# 1995 - 1996 Corvette: Service Bulletin: Transmission Fluid Leak From Pump Body

**Subject:** Transmission Fluid Leak From Pump Body (Replace Bushing)

**Bulletin Number:** 57-71-26B

Figure 1 - Hydra-Matic 4L60-E Transmission Identification Information

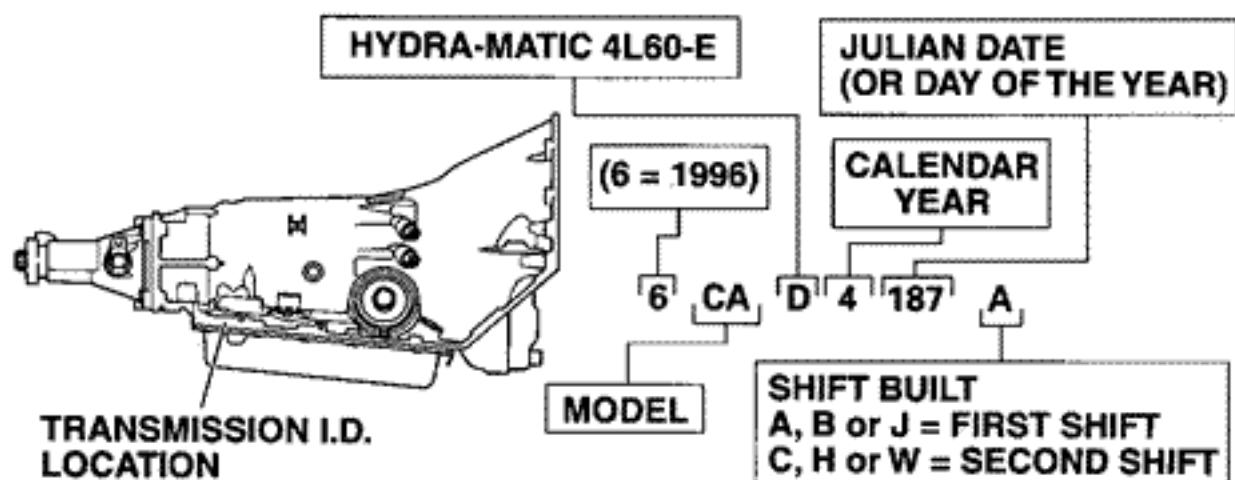
(FIGURE 1) SOME OWNERS MAY EXPERIENCE A PUMP FLUID LEAK. STARTING SEPTEMBER 11, 1995 (JULIAN DATE 254) ALL UNITS ARE BUILT USING A REVISED DESIGN BODY BUSHING.

**Figure 2 - Remove Front Helix Retainer**

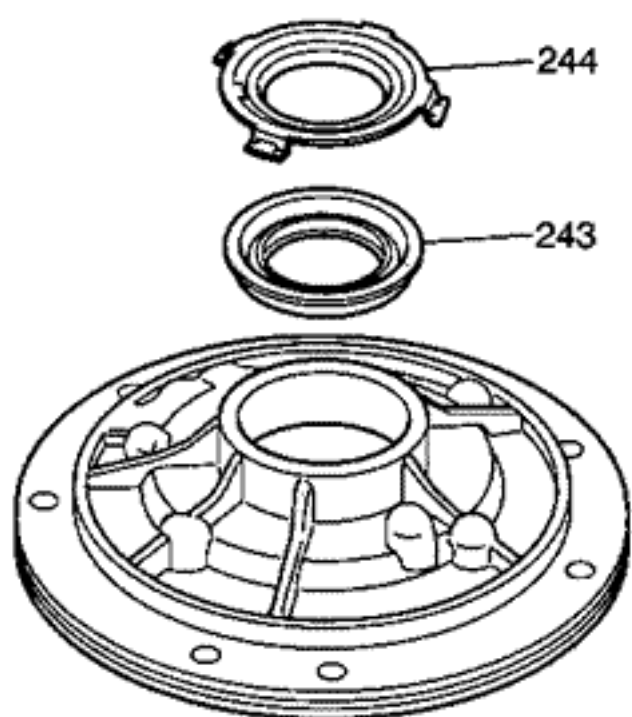
THE PUMP BUSHING IS SPINNING OR WALKING OUT OF THE BODY.

1. REMOVE THE FRONT HELIX RETAINER (244). 2. REMOVE THE OIL SEAL ASSEMBLY (243). 3. REMOVE THE PUMP BODY BUSHING (242) USING TOOL J41778-1. 4. INSTALL NEW BUSHING USING J41778-2 AS A POSITIVE STOP AND AN ARBOR PRESS WITH J41778-1.
